Request for Proposal - ADDENDUM No. 3

PROJECT NAME & NO.: Government Solar Development Project SPVPP04

RE: Q&A Round#2 / New and Amended Documents

Annex C - Government's Master Specifications Amended

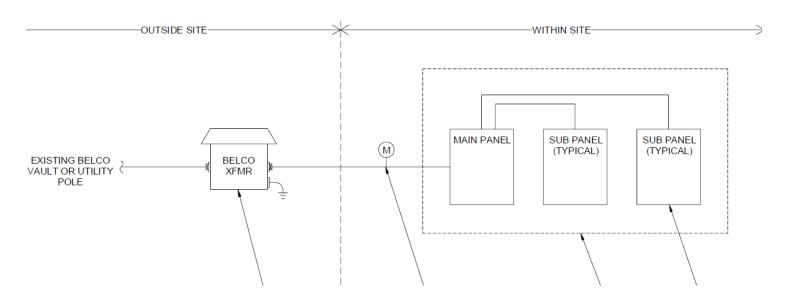
Please review **Annex C - Government's Master Specifications Amended** document which has been edited to include: Inverters/power conditioning units shall have a warranty for failures due to material defects and workmanship for at least 10 years.

2.	Inverter/ Power Conditioning Units	The proposed inverter shall be of hybrid type and have: 2.1 a warranty for failures due to material defects for at least 10 years 2.2 a workmanship warranty for at least 1 year.
